Fender Bandmaster
AB763
Vibrato Circuit
Original

Fender Bandmaster
AB763
Vibrato Circuit
Modification

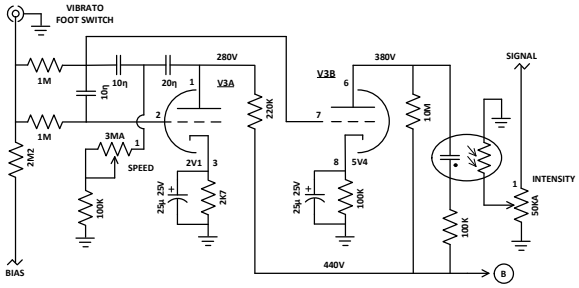
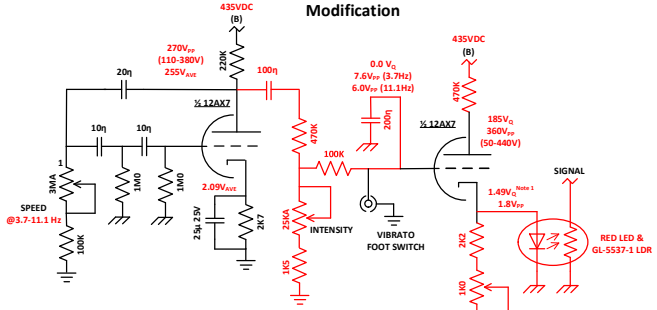
1. Adjust the bias voltage (V_Q) for a new circuit or if the LED, LDR, or 12AX7 are changed in an existing circuit, until the LDR reads 3M-4M resistance (out of circuit) with the vibrato off and record voltage for future adjustment. Return bias voltage (V_Q) to noted value during servicing if needed.
